UNITED STATES
DEPARTMENT OF THE INTERIOR
BUREAU OF LAND MANAGEMENT

FORM APPROVED
OMB NO. 1004-0137
Expires: January 31, 2018HOBBS OCD
JAN 23 2017
RECEIVED**SUNDRY NOTICES AND REPORTS ON WELLS**
*Do not use this form for proposals to drill or to re-enter an abandoned well. Use form 3160-3 (APD) for such proposals.***SUBMIT IN TRIPLICATE - Other instructions on page 2**

EOG Resources requests an amendment to our approved APD for this well and the approved APD for the Barlow 27 Fed Com 702H to reflect the following changes:

BARLOW 27 FED COM 701H

BARLOW 27 FED COM CTB
FLOWLINE

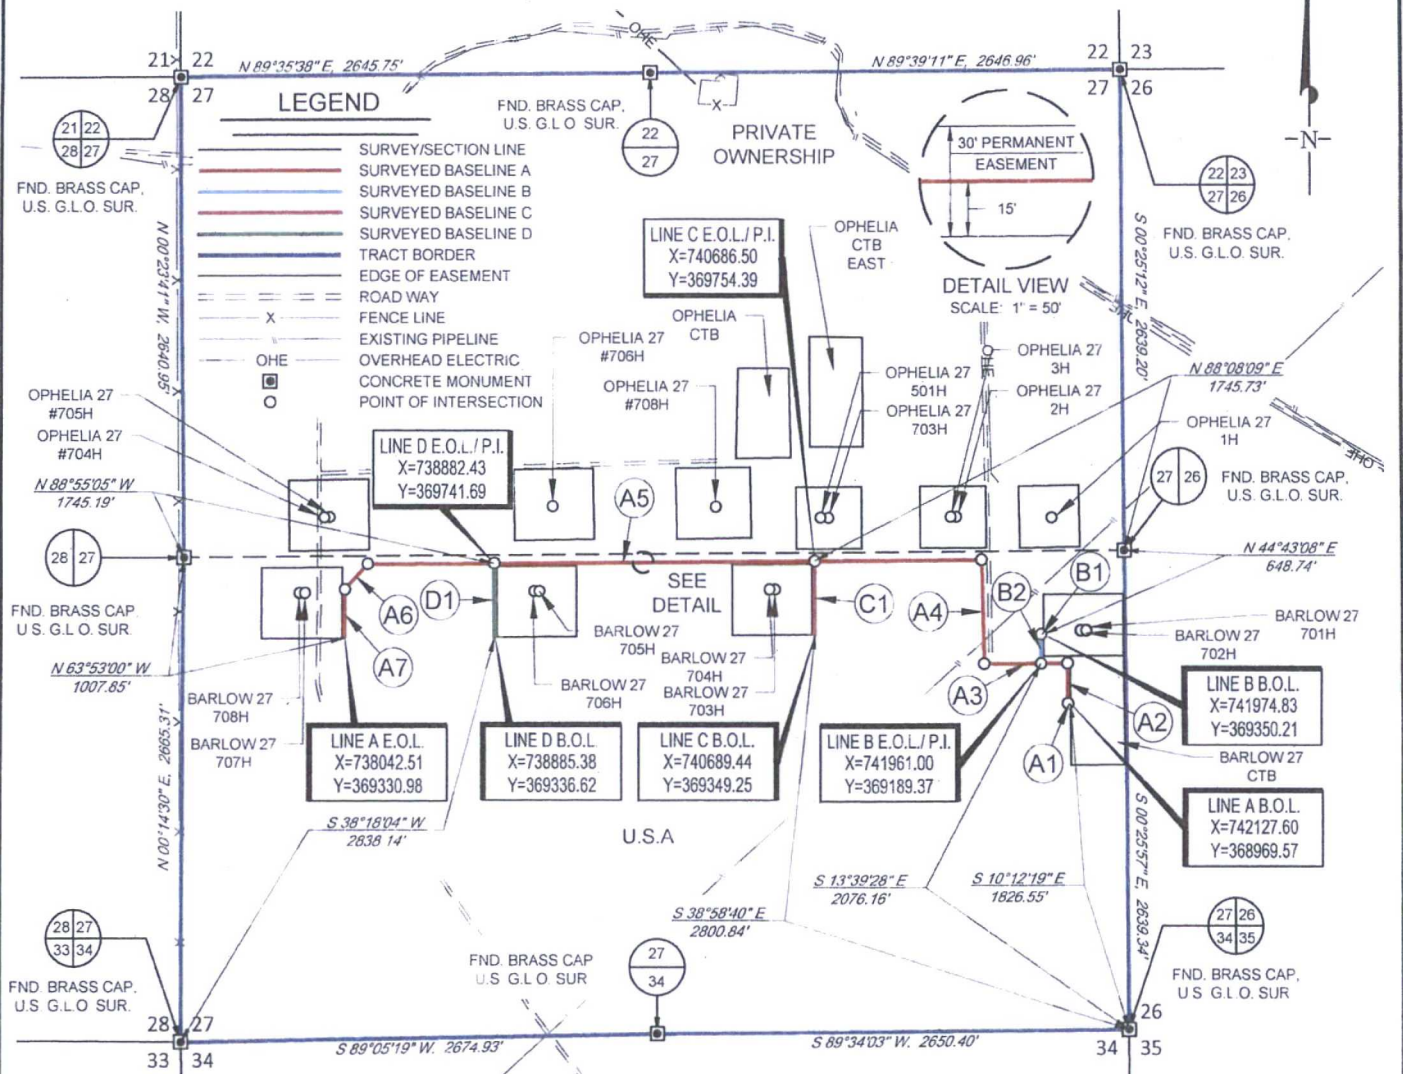
Pad size needs to be 390 x 450. 250 on the north and 140 on the south.
CTB will now be off pad instead of on the well pad. Flowline plat attached from well to CTB.
We will need a temporary 24 foot road only for the drilling and completion of the dual wells. Once well is completed road will be reclaimed.

Being a proposed flow line easement being 30 feet in width, 15 feet left, and 15 feet right of the above platted baseline total line footage containing 6181.37 feet or 374.63 rods, containing 4.26 acres more or less.
